Intersection ID: 25628	Main Street: WINDSWEPT_DR	Cross Street: PINEVILLE-MATTHEWS_RD	Location:	SE
ADA ID: 850E1E03170D	Ramp Type: Perp	Initial Pass/Fail: Fail	Overall Compliance: No	Severity Score: 8.75

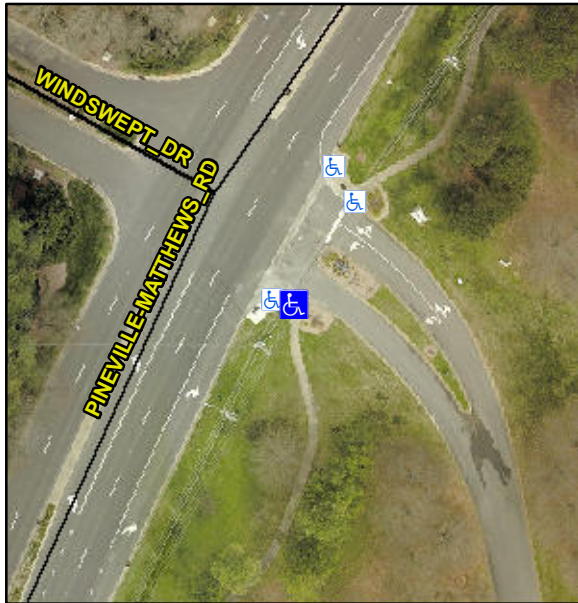
Not Found, R304.5.1

Compliance	Description	Data	Compliance	Description	Data
N/A	Ramp Length (in)	46.0	Yes	Ramp Slope (%)	8.3
No	Ramp Width (in)	38.0	Yes	Ramp XSlope (%)	0.5
N/A	Flare Type LT	N/A	N/A	Flare Type RT	N/A
N/A	Flare Slope LT (%)	N/A	N/A	Flare Slope RT (%)	N/A
N/A	Flare Traversable LT?	N/A	N/A	Flare Traversable RT?	N/A
N/A	Landing Length (in)	N/A	N/A	DWS Provided?	N/A
N/A	Landing Width (in)	N/A	N/A	DWS Contrast?	N/A
N/A	Landing Slope (%)	N/A	N/A	DWS Length (in)	N/A
N/A	Landing X Slope (%)	N/A	N/A	DWS Full Width?	N/A
N/A	Landing Curb? (Y/N)	N/A	N/A	DWS Offset (in)	N/A
N/A	Shared Landing?	N/A			
N/A	Gutter Ponding?	N/A	N/A	Gutter Slope (%)	N/A
N/A	Gutter Lip Ht (in)	N/A	N/A	Gutter X Slope (%)	N/A
N/A	Painted X Walk1?	No	N/A	Painted X Walk2?	N/A
	X Walk 1 Direction	To NE		X Walk 2 Direction	N/A
N/A	X Walk 1 Width (in)	N/A	N/A	X Walk 2 Width (in)	N/A
	X Walk 1 Slope (%)	6.2		X Walk 2 Slope (%)	N/A
	X Walk 1 X Slope (%)	2.1		X Walk 2 X Slope (%)	N/A

Remove & Replace Entire Ramp.
